# UNITED STATES PATENT AND TRADEMARK OFFICE

APPLICATION NO.	FILING DATE	FIRST NAMED INVENTOR	ATTORNEY DOCKET NO.	CONFIRMATION NO.
10/790,923	03/01/2004	Nancy C. Frye	063293.0110	1435
5073	7590	10/28/2005	EXAMINER	
BAKER BOTTS L.L.P. 2001 ROSS AVENUE SUITE 600 DALLAS, TX 75201-2980			PATTERSON, MARIE D	
			ART UNIT	PAPER NUMBER
			3728

## Office Action Summary

FIG. 12

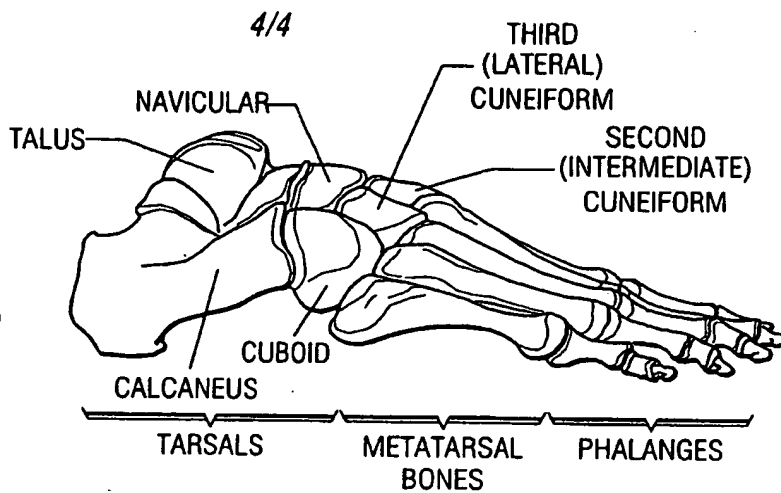
3. The drawings were received on 10/26/05. These drawings are not entered because they contain new matter, i.e. the thickness, shape, exact location, etc. of the midsole is considered to be new matter. In response applicants' arguments directed towards the new matter added to the drawings in order to show the midsole, it is noted that it is applicants' responsibility when originally filing the application to ensure that all claimed elements are clearly shown in the drawings, the addition of elements at a later date in most cases does add new matter and will not be entered.
4. The drawings are objected to under 37 CFR 1.83(a). The drawings must show every feature of the invention specified in the claims. Therefore, the midsole(s) must be shown or the feature(s) canceled from the claim(s). No new matter should be entered.
